TECHNICAL NOTE

Job Name: Pump Farm Lower Rainham
Job No: 44538
Note No: 44538/TN001
Date: January 2020
Prepared By: Iris Kalaci
Subject: **Surface Water Drainage Strategy Addendum**

The latest surface water drainage proposals and catchments are detailed in drawing 44538/2001/001 included in **Appendix B**. The latest Micro-Drainage surface water drainage modelling and calculations are included in **Appendix D**.

Drawing Number: 44538/2001/001
Revision: D

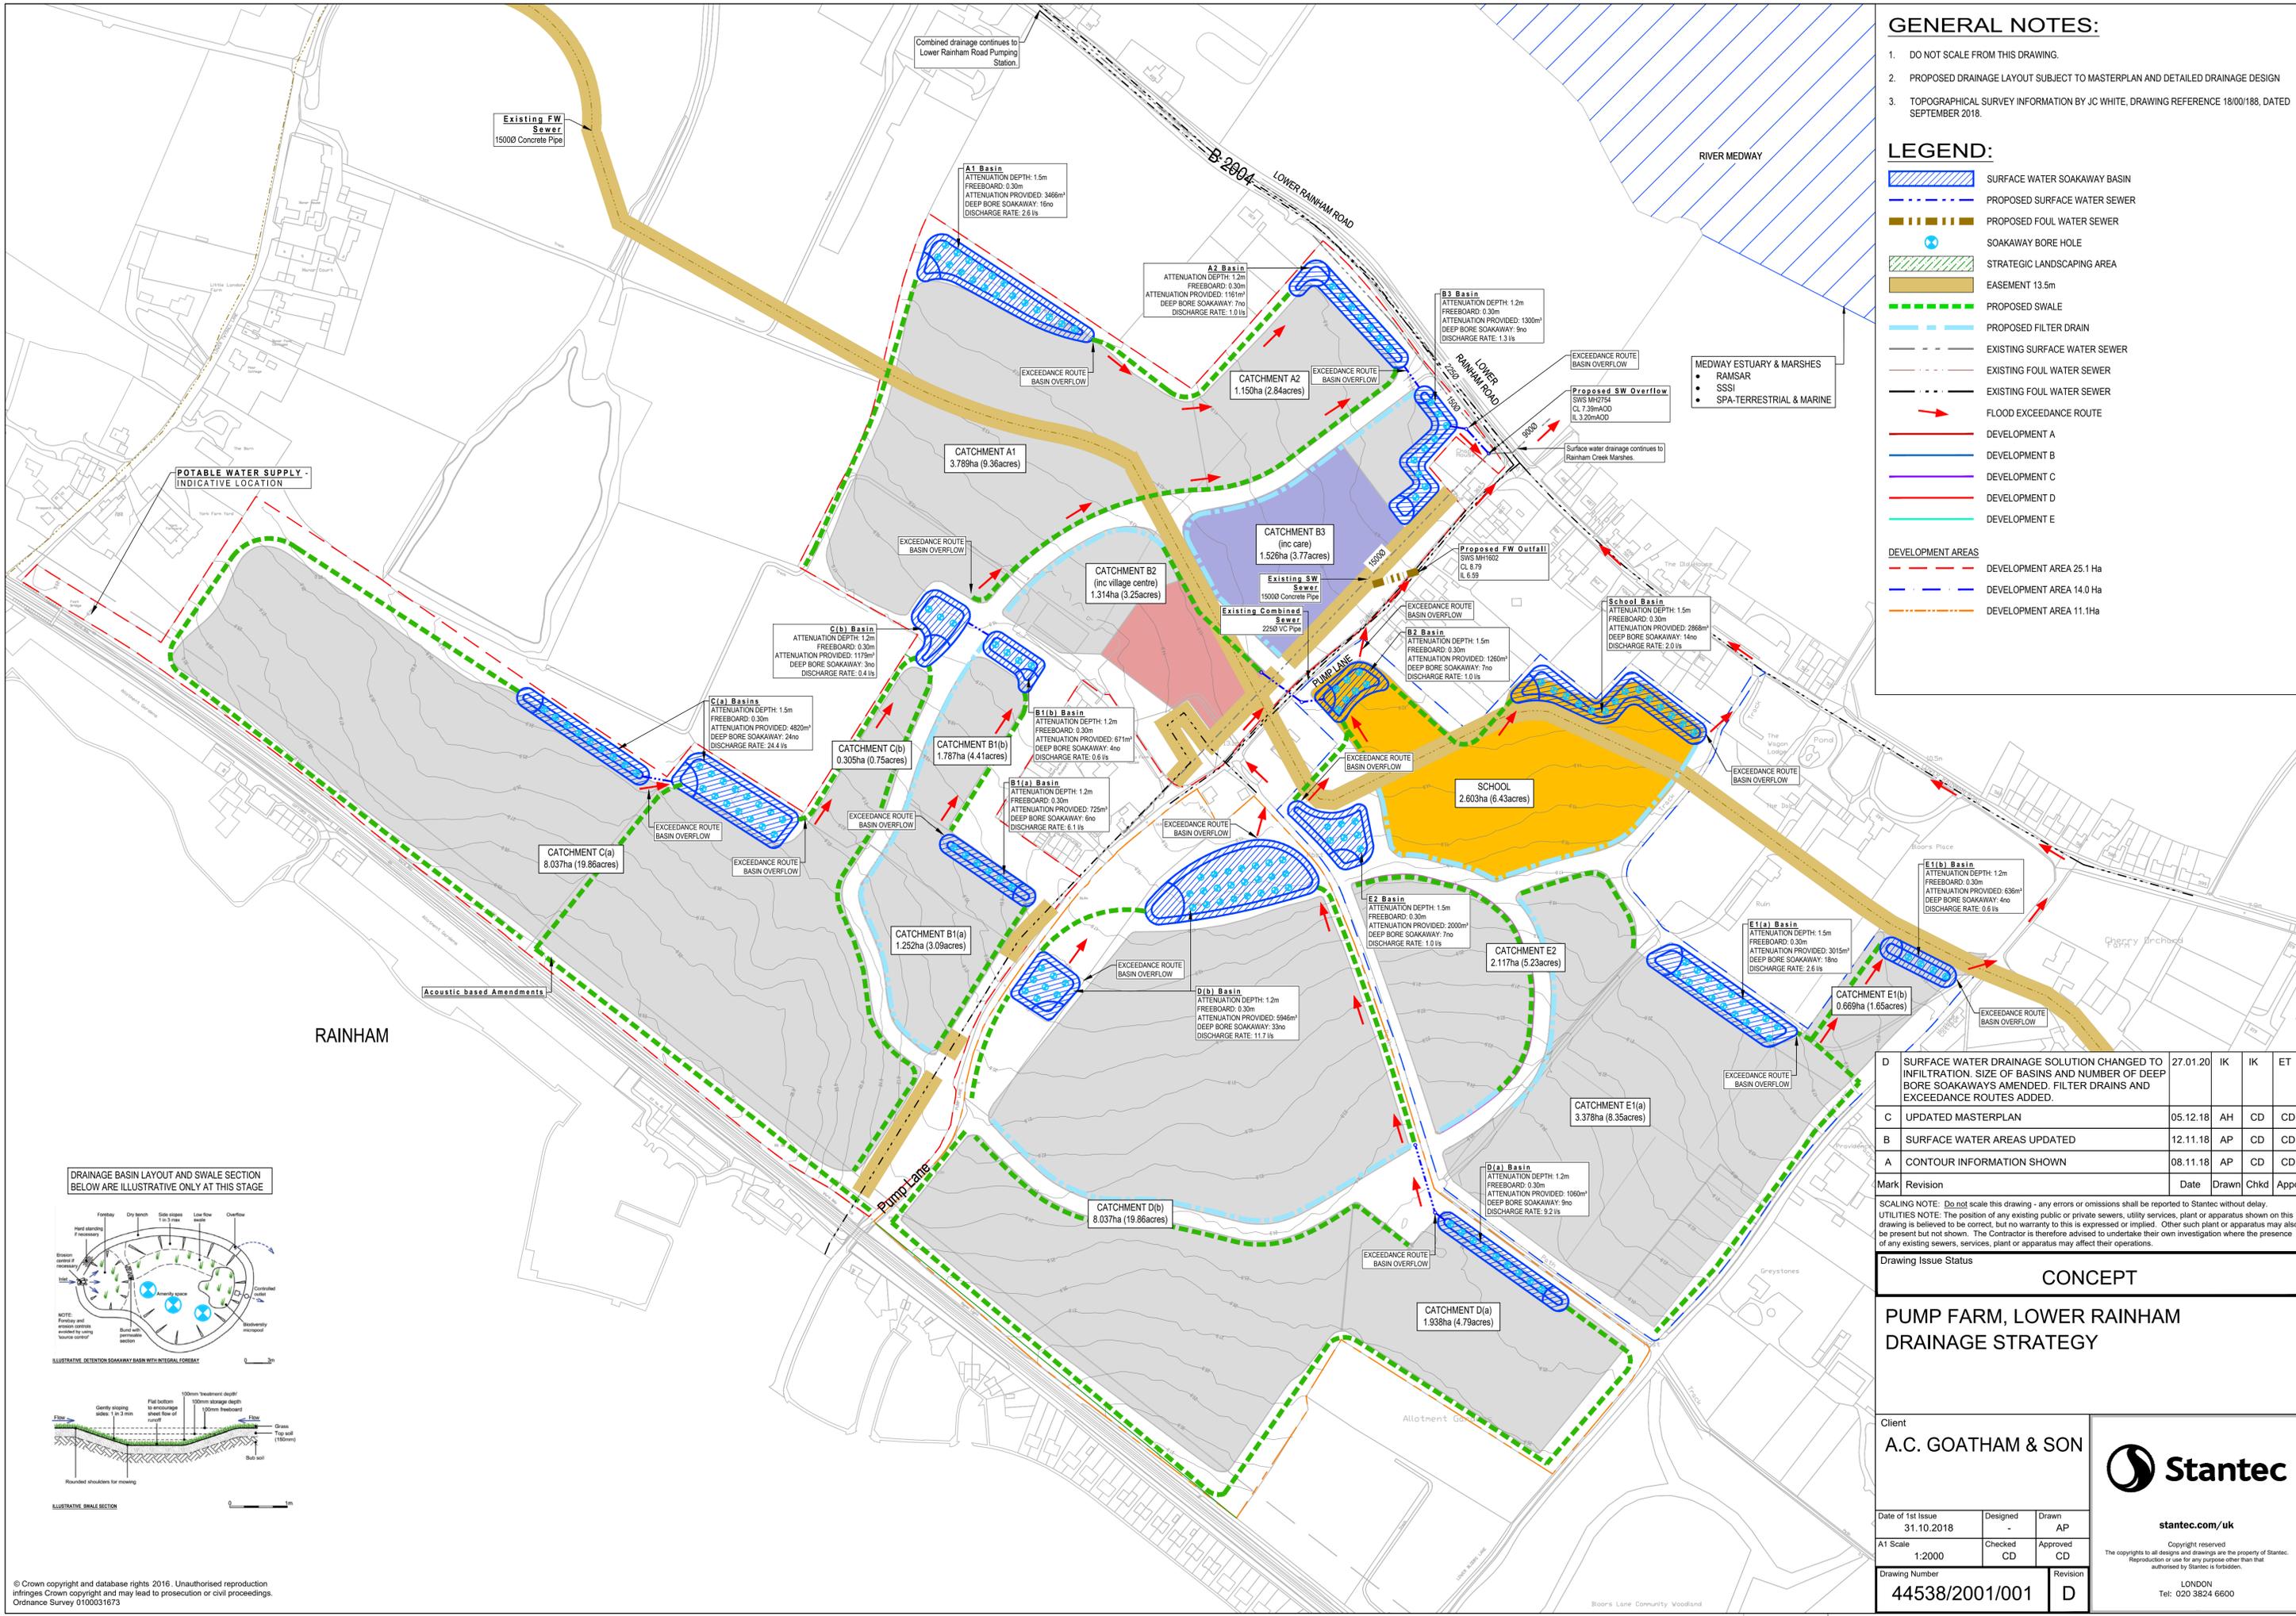
D	SURFACE WATER DRAINAGE SOLUTION CHANGED TO INFILTRATION. SIZE OF BASINS AND NUMBER OF DEEP BORE SOAKAWAYS AMENDED. FILTER DRAINS AND EXCEEDANCE ROUTES ADDED.	27.01.20	IK	IK	ET
C	UPDATED MASTERPLAN	05.12.18	AH	CD	CD
B	SURFACE WATER AREAS UPDATED	12.11.18	AP	CD	CD
A	CONTOUR INFORMATION SHOWN	08.11.18	AP	CD	CD
